NRC RAI Letter No. PTN-RAI-LTR-041

SRP Section: 02.05.01 - Basic Geologic and Seismic Information

NRC RAI Number: 02.05.01-33 (eRAI 6024)

Proposed Turkey Point Units 6 and 7
Docket Nos. 52-040 and 52-041
FPL Draft Revised Response to NRC RAI No. 02.05.01-33 (eRAI 6024)
Page 6 of 6

Figure 3. The two zones of secondary porosity on B-710 G (DH) showing the lithology, caliper, natural gamma, velocity (Vs and Vp) and acoustic televiewer logs (1 of 5)

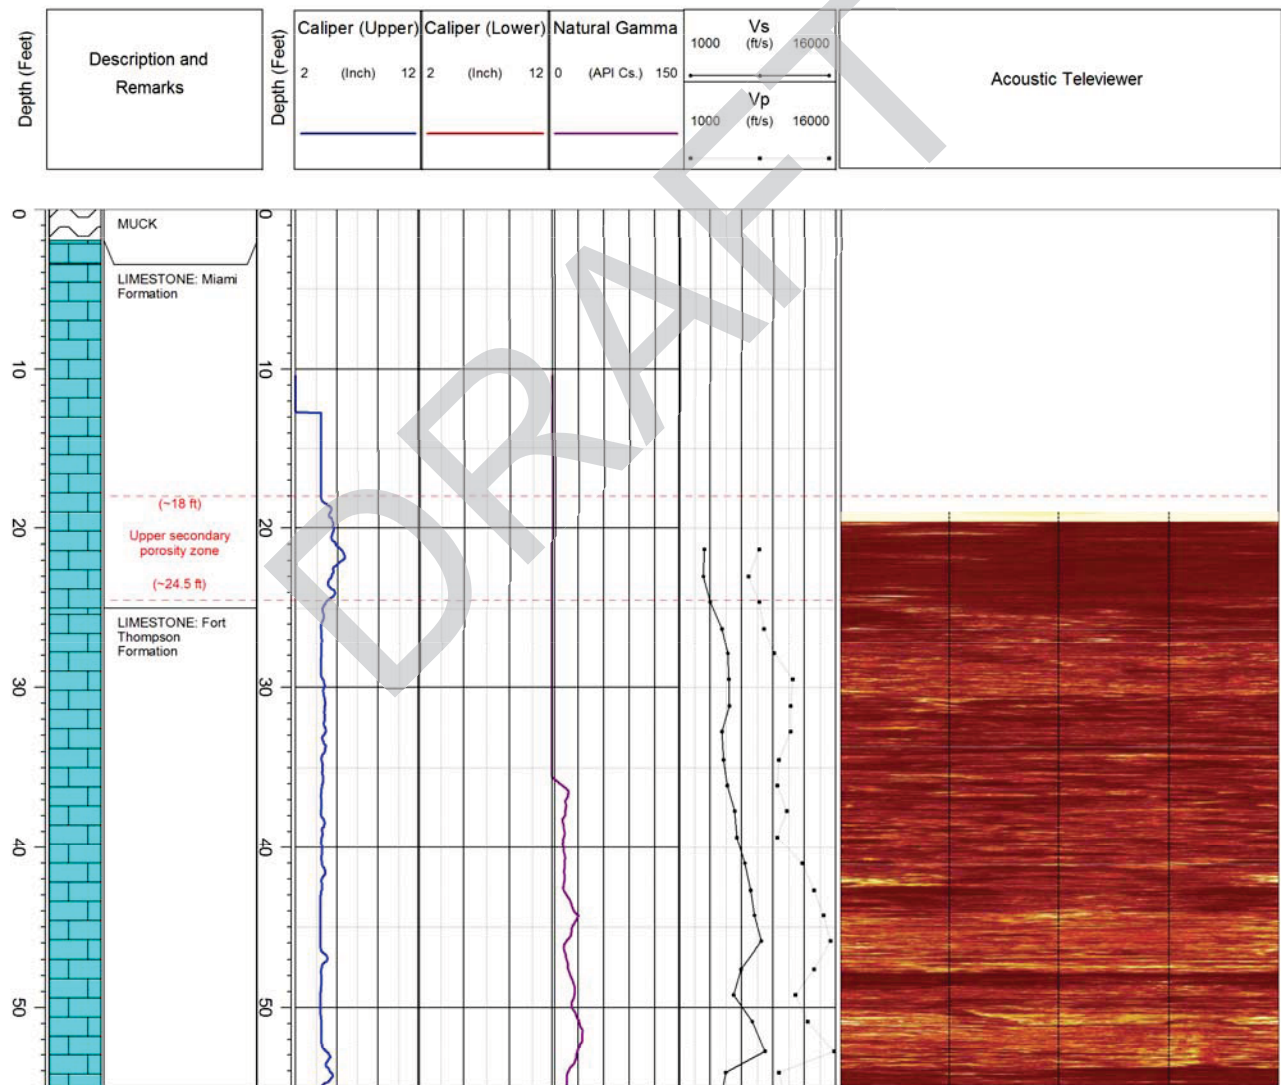
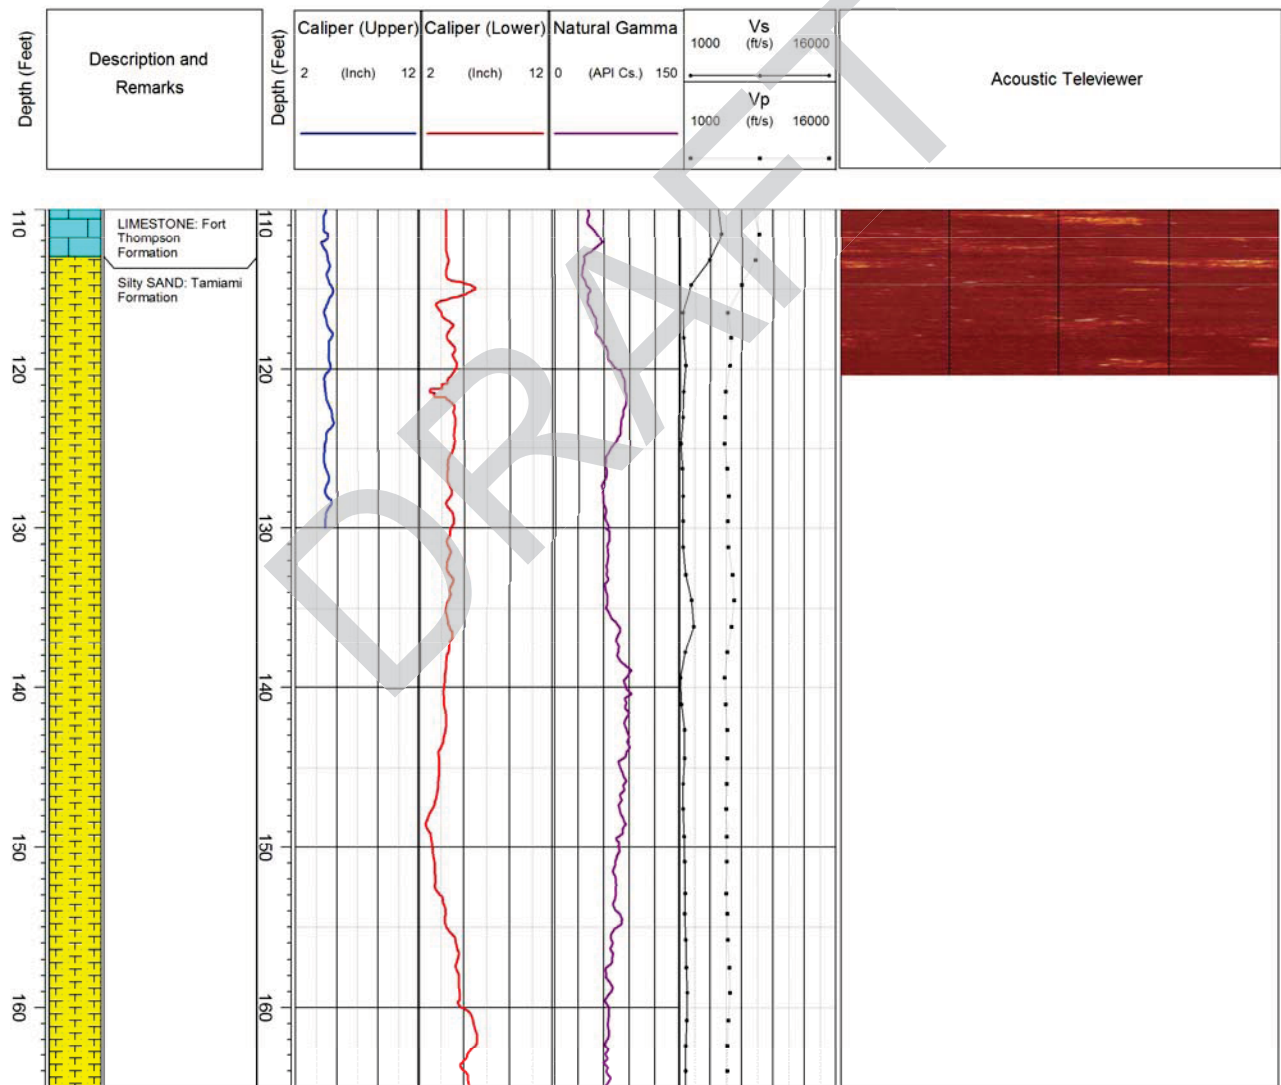
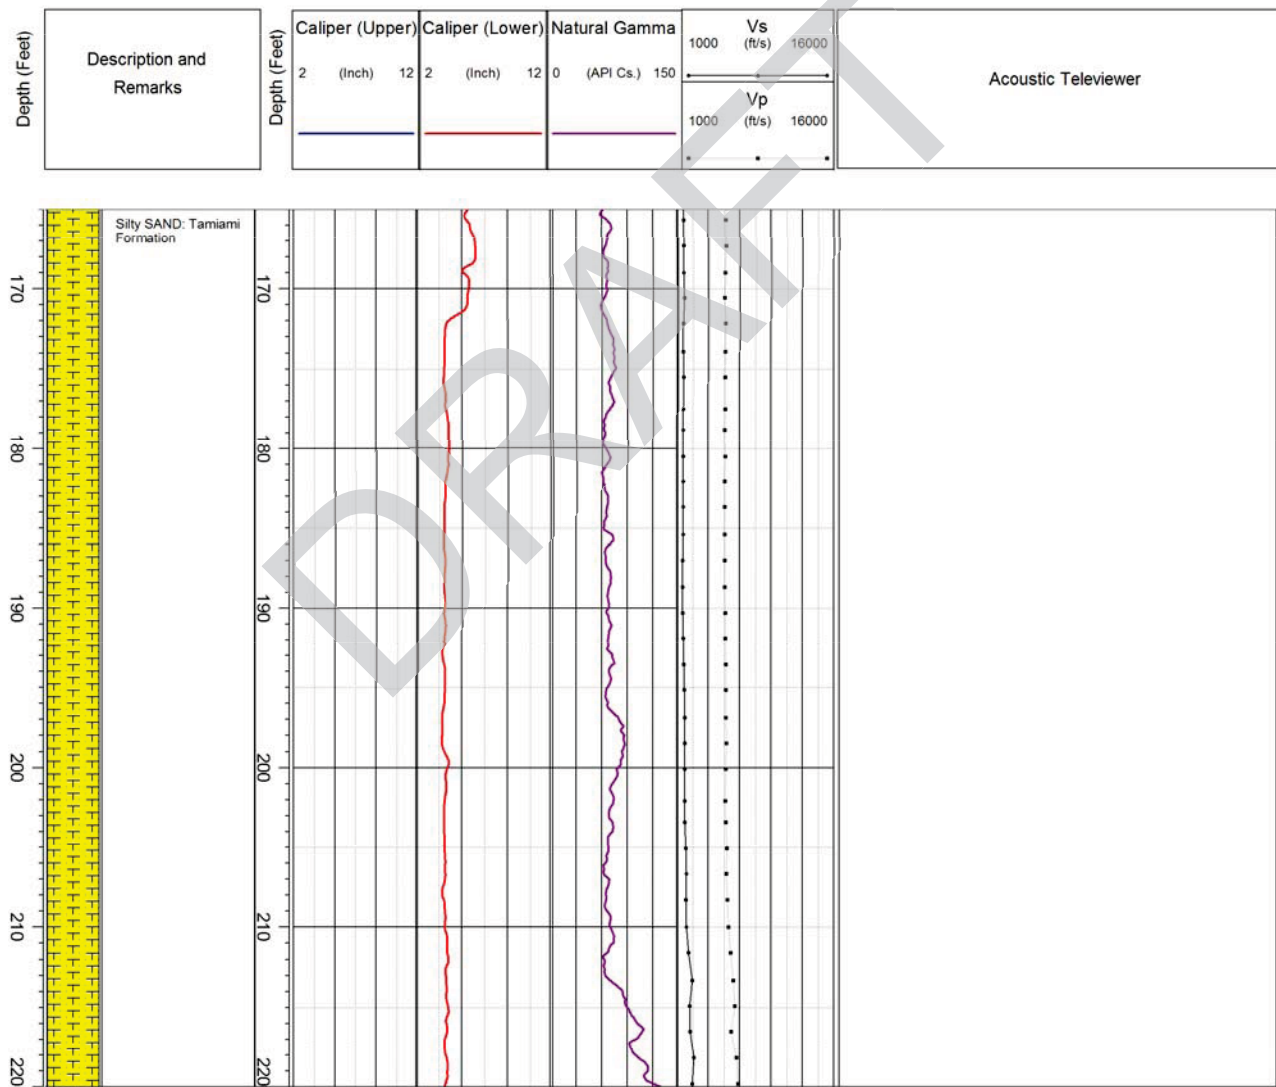
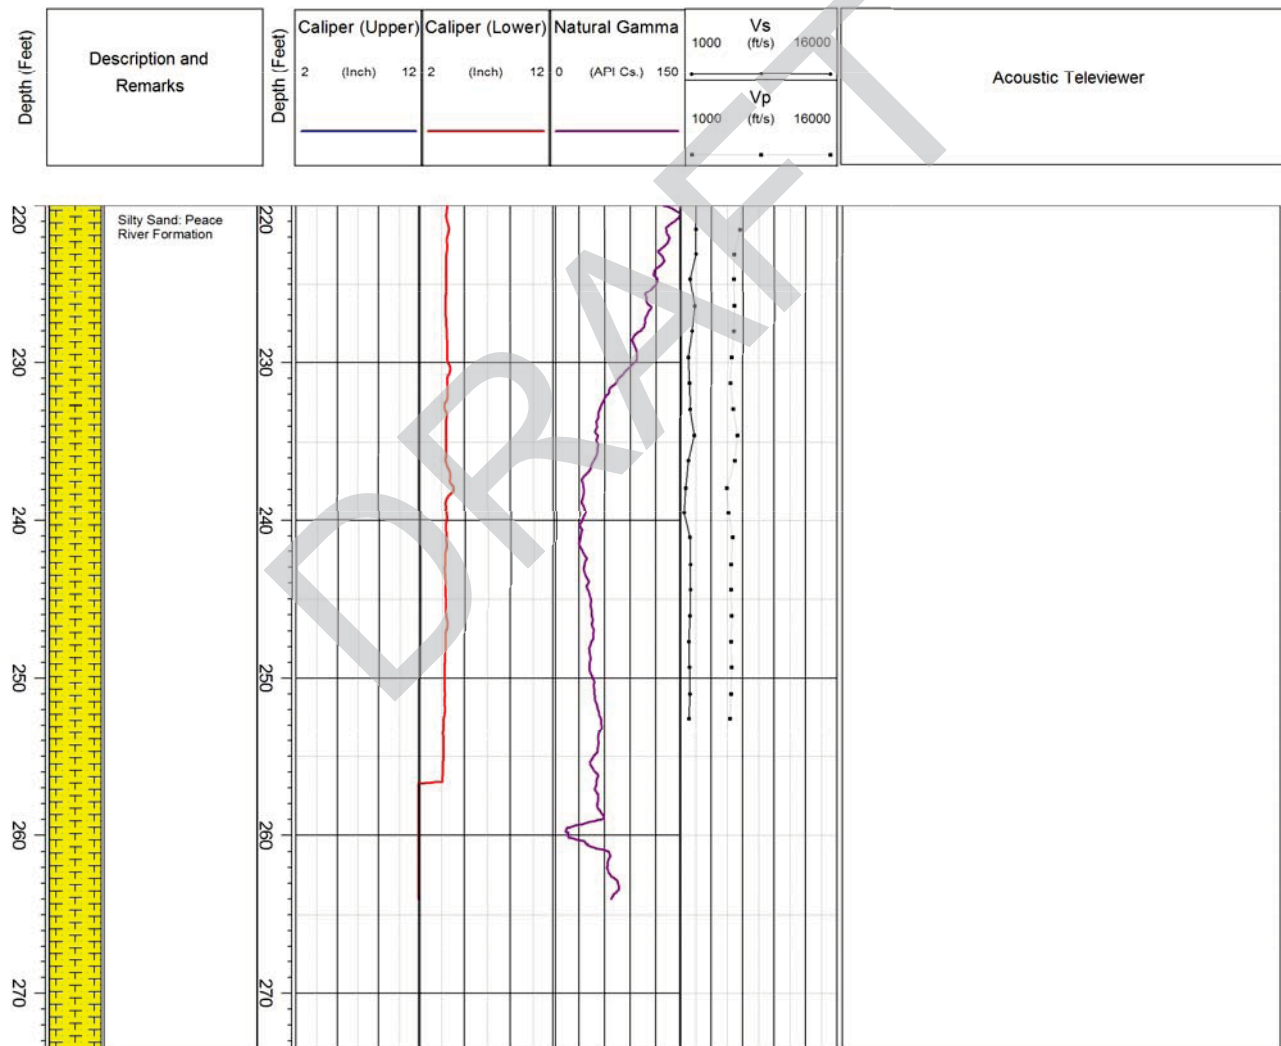
FSAR Section 2.5.1.2.4 discusses limestone dissolution features and states that zones of preferential secondary porosity exist within (1) an upper zone within Key Largo Limestone and (2) a lower zone within Fort Thompson Formation, and that these zones include cavities verified from televiwer and caliper logs. Staff notes that the Key Largo LS will be the bearing layer for SSC buildings. In order for the staff to evaluate the dissolution potential at the TPNPP site and in support of 10 CFR 100.23, please address the following:

- a) Discuss the possible origins of these subsurface voids and evaluate if this is still consistent with your statement “there is no evidence for sinkhole hazards or for the potential of surface collapse due to the presence of large underground openings” on page 2.5.1-229.
- b) Discuss the possibility that these zones of secondary porosity are in the same stratigraphic unit that expresses the karst/sinkhole-like features seen immediately off shore to the east of the TPNPP site.

As described in FSAR Subsection 2.5.1.2.4, the two zones of secondary porosity were identified at the site following review of the geophysical logs, the geotechnical boring logs, and the shear wave velocity logs. In general, the zones of secondary porosity were identified based on increases in borehole diameter on the caliper logs, darkened areas on the acoustic televiwer images, typically lower P-S wave velocity values, and loss of drilling fluid and rod drops. Figures 1 through 3 show the approximate locations of the two zones of secondary porosity on three example-boring logs, B-604 (DH), B-608 (DH), and B-710 G (DH) and their locations at the Turkey Point Units 6 & 7 site are seen on FSAR Figure 2.5.1-228 and FSAR

Figure 2.5.4-202. Figures 1 through 3 were compiled using the lithology, caliper, natural gamma, acoustic televiwer, and velocity (Vs and Vp) logs.

Figure 1A. Fault Map of Western Cuba Showing Earthquakes from the Project Phase 2 Earthquake Catalog.

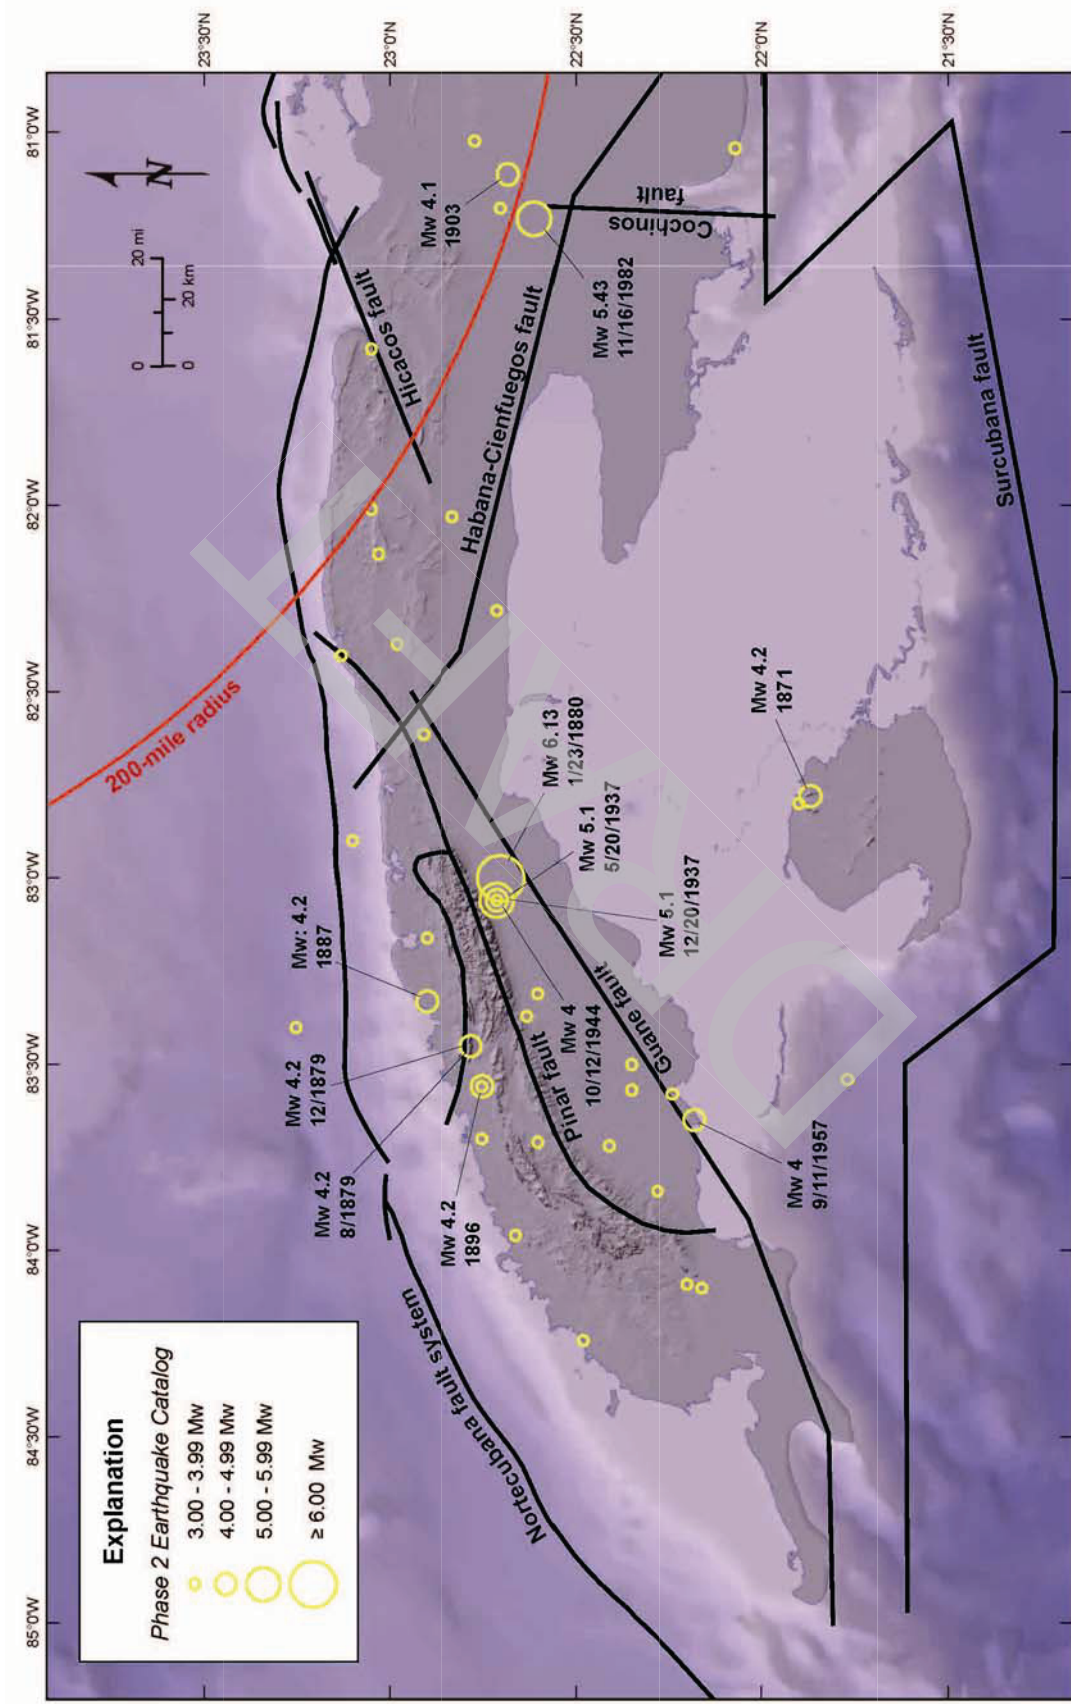
- a) Provide a map of the Cochinos fault with respect to topography and bathymetry, and discuss if the association of the Cochinos fault with bathymetric relief provides geologic evidence for activity.
- b) Map seismicity with respect to the Cochinos fault trace, showing location uncertainties, and discuss the relationship of the fault to seismicity.

Various researchers present different locations and extents for the Cochinos fault. For example, Figures 1A and 1B show the location of the Cochinos fault after Hall et al. (2004) (FSAR Reference 770), who indicate the fault at its nearest point is approximately 205 miles (330 kilometers) from the Turkey Point Units 6 & 7 site. Cotilla-Rodriguez et al. (2007) (FSAR Reference 494) suggest this fault may extend northward to within 175 miles (280 kilometers) of the site, whereas mapping by Mann et al. (1990) (FSAR Reference 493) indicates a closest distance of approximately 210 miles (340 kilometers).

Earthquake location errors are not shown on Figures 1A and 1B because the data with which to estimate these errors for each earthquake are not available. According to Cotilla-Rodríguez et al. (2007) (FSAR 2.5.1 Reference 494, p.518), the "epicenter determination [for earthquakes] in the western, central, and central-eastern [portions of Cuba] have limitations because of scarce or no permanent seismic stations." Regarding the locations of pre-instrumental earthquakes in Cuba, Garcia et al. (2003) (FSAR 2.5.1 Reference 489, p. 2,569) state that, "Taking into account the complexity of the Cuban tectonic environment, the poor knowledge about the kinematic evolution of the principal fault systems, and the uncertainty in the hypocentral location of historical events (uncertainty of 15-20 kilometers or more in the historical coordinates is reasonable), it is impossible to associate earthquakes with individual faults." Therefore, the association of this sparse seismicity with the Cochinos fault or another mapped or unmapped fault in the vicinity is problematic due to the uncertainties associated with the locations of both faults and earthquakes in Cuba.
